# FORT IRWIN HOSPITAL REPLACEMENT ELECTRICAL SITE UTILITY PLAN

BUL-03 Revision 1

Turner DC #029 PCO #104  
Received by Turner Construction via RFP 013 2/26/14

1	SCE REQUESTED OFF-SITE ELECTRICAL CHANGES	2.5-14	K14
	Sum A	Discrepancy	Approved

Sheet  
Reference  
Number  
**ES109**

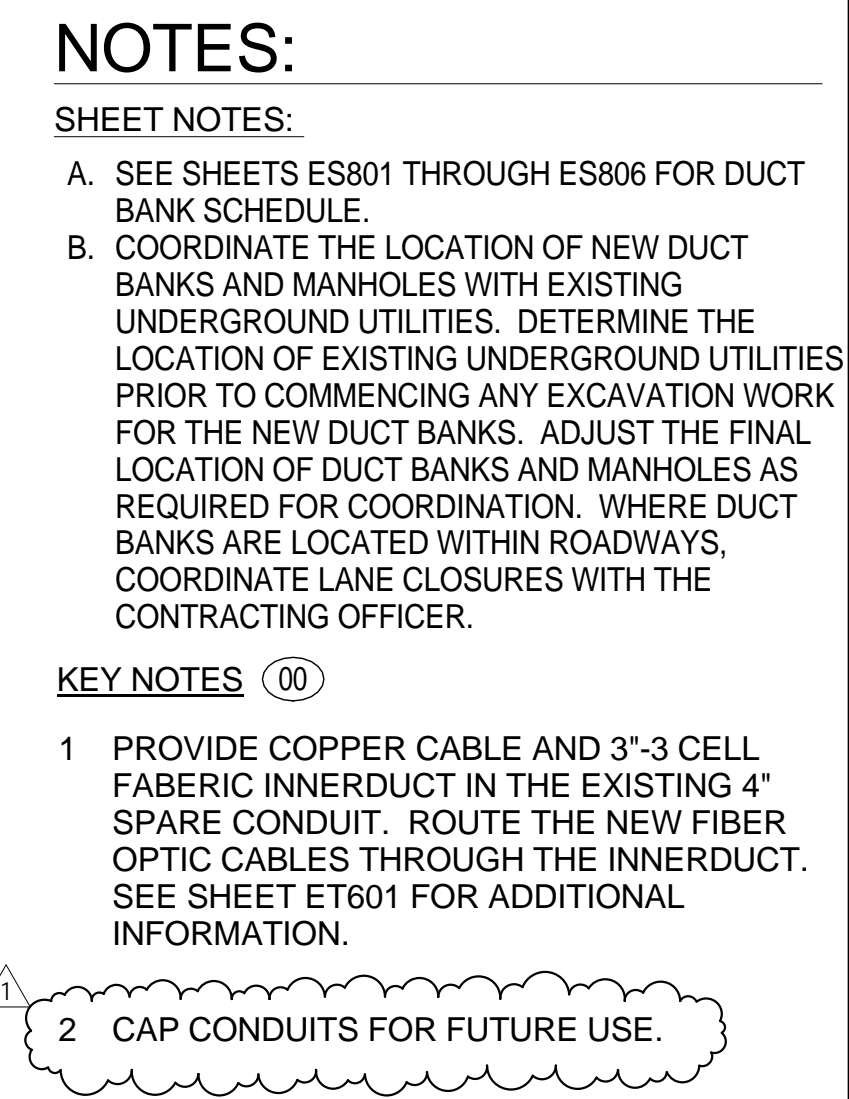
- 1 SCE 1800KVAR CAPACITOR AND CONCRETE PAD. COORDINATE EXACT LOCATION WITH SCE. CAPACITOR AND PAD PROVIDED BY SCE, FUNDED BY PROJECT.
- 2 CAP CONDUITS FOR FUTURE USE.

Sheet  
Reference  
Number  
**ES113**  
SHEET 1589 OF 1985

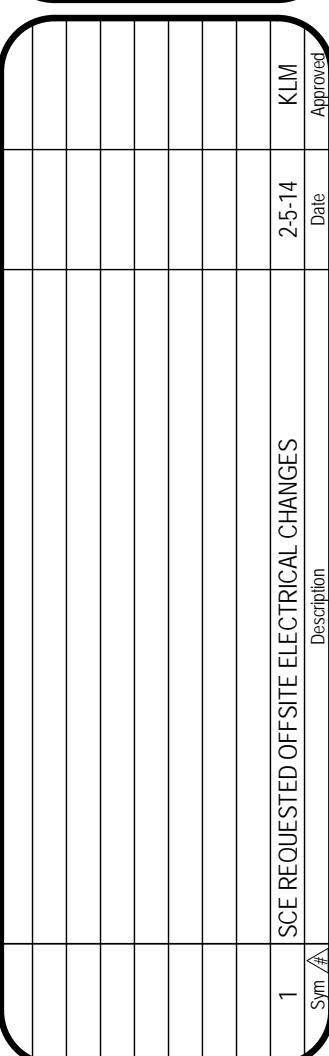
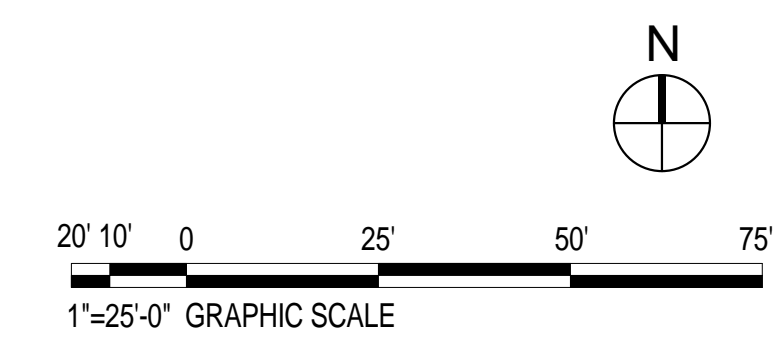
- 1 PROVIDE COPPER CABLE AND 3"-3 CELL FABRIC INNERDUCT IN THE EXISTING 4" SPARE CONDUIT. ROUTE THE NEW FIBER OPTIC CABLES THROUGH THE INNERDUCT. SEE SHEET ET601 FOR ADDITIONAL INFORMATION.
- 2 CAP CONDUITS FOR FUTURE USE.

Sheet  
Reference  
Number  
**ES120**

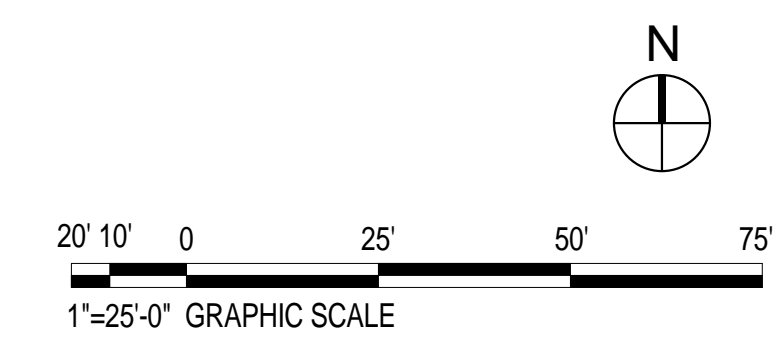
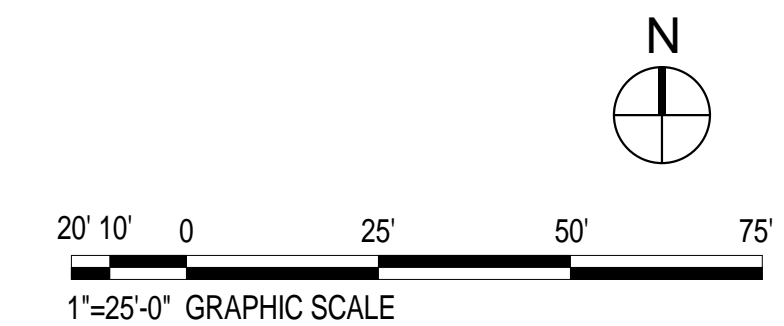
- 1 EXISTING SCE PRIMARY POWER MANHOLE.
- 2 EXISTING SCE PRIMARY POWER DUCT BANK.
- 3 CONNECT TO EXISTING SCE PRIMARY POWER DUCT BANK. COORDINATE ALL WORK AT CONNECTION POINT WITH SCE.
- 4 CAP CONDUITS FOR FUTURE USE.

Sheet  
Reference  
Number  
**ES123**

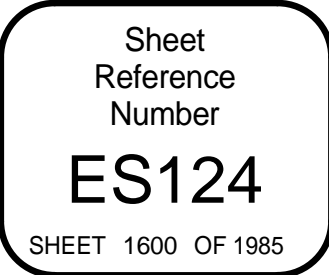
- 1 PROVIDE 3"-3 CELL FABRIC INNERDUCT IN THE EXISTING 4" SPARE CONDUIT. ROUTE THE NEW FIBER OPTIC CABLES THROUGH THE INNERDUCT. SEE SHEET ET601 FOR ADDITIONAL INFORMATION.
- 2 MANHOLE CONTAINING EXISTING 200 PIAR COPPER CABLE DEDICATED TO SERVE THE REPLACEMENT HOSPITAL. SPLICE NEW 200 PIAR COPPER CABLE TO EXISTING CABLE IN THIS MANHOLE. SEE ET601 FOR ADDITIONAL INFORMATION.
- 3 PROVIDE COPPER CABLE AND 3"-3 CELL FABRIC INNERDUCT IN THE EXISTING 4" SPARE CONDUIT. ROUTE THE NEW FIBER OPTIC CABLES THROUGH THE INNERDUCT. SEE SHEET ET601 FOR ADDITIONAL INFORMATION.
- 4 EXTEND FIBER OPTIC CABLE TO EXISTING RACK IN BUILDING 147 AND PROVIDE PATCH PANEL AND TERMINATIONS AS INDICATED ON SHEET ET601. COORDINATE WITH FT. IRWIN NEC.

ES132

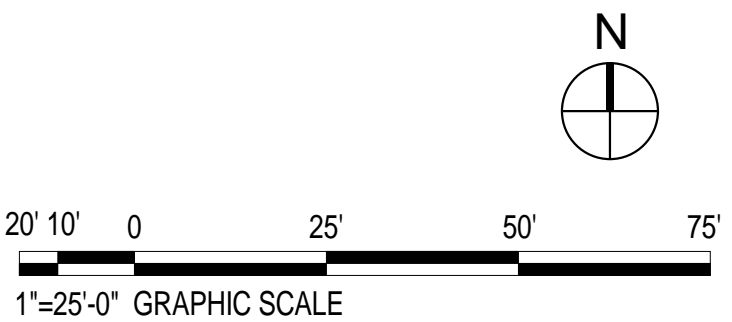
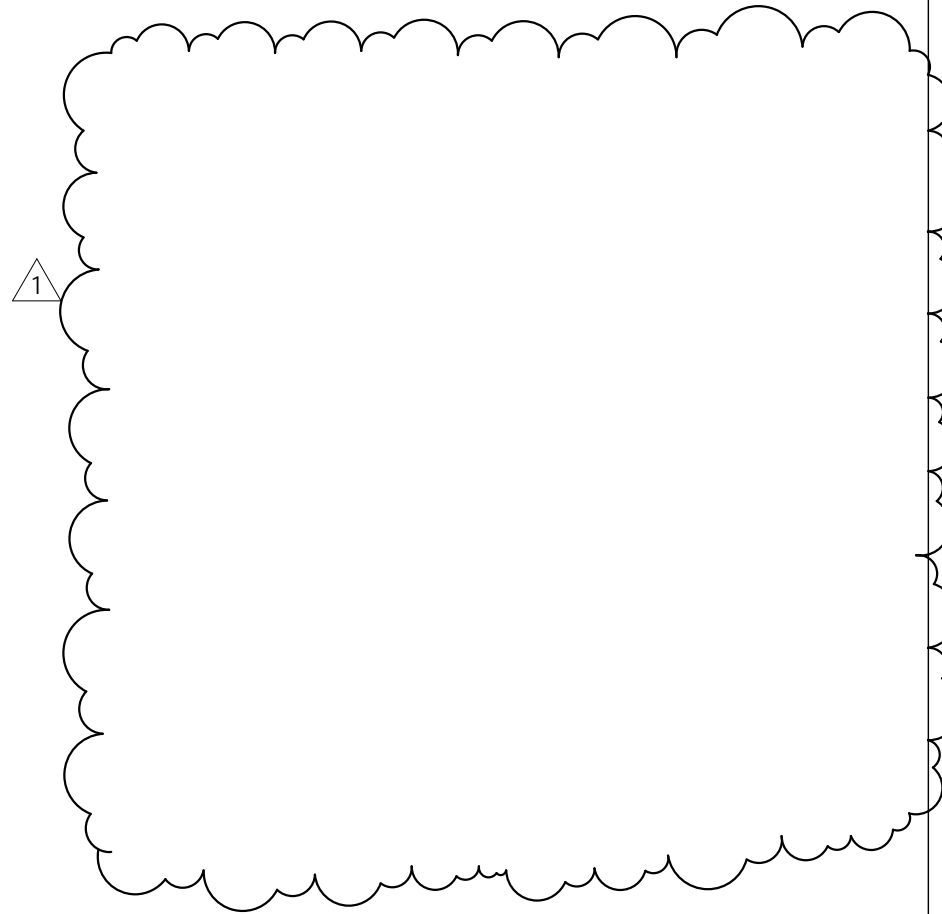
1 UTILIZE EXISTING SPARE 1 1/4" INNERDUCT TO ROUTE FIBER OPTIC CABLE. SEE SHEET ET601 FOR ADDITIONAL INFORMATION.

3 12-WAY DUCT BANK DETAIL  
NO SCALE

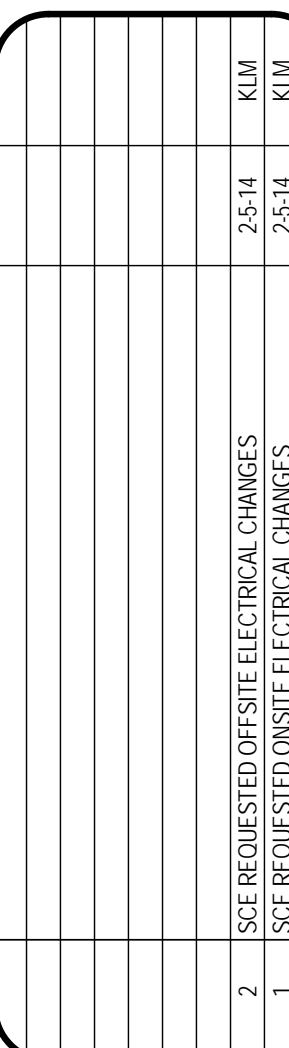
1. PITCH DUCT BANKS 4 INCHES/100 FEET TO DRAIN TOWARDS MANHOLES.
2. CONNECT THE #4/0 BARE COPPER GROUND CONDUCTOR TO THE GROUND RODS LOCATED IN THE MANHOLES.
3. PROVIDE DUCT SPACERS AT 5'-0" ON CENTER MAX.
4. CONCRETE SHALL BE 3000 P.S.I. @ 28 DAYS, OR AS SPECIFIED.
5. PROVIDE #4 REINFORCING RODS ON TOP AND BOTTOM OF DUCT BANKS 8" ON CENTER, BOTH WAYS, WHEN CROSSING OR PLACED IN ROADWAYS AND WITHIN 10' AWAY FROM A BUILDING OR MANHOLE ENTRANCE.
6. NON-FERROUS TIE WIRES TO BE IMBEDDED IN DUCT BANK CONCRETE.
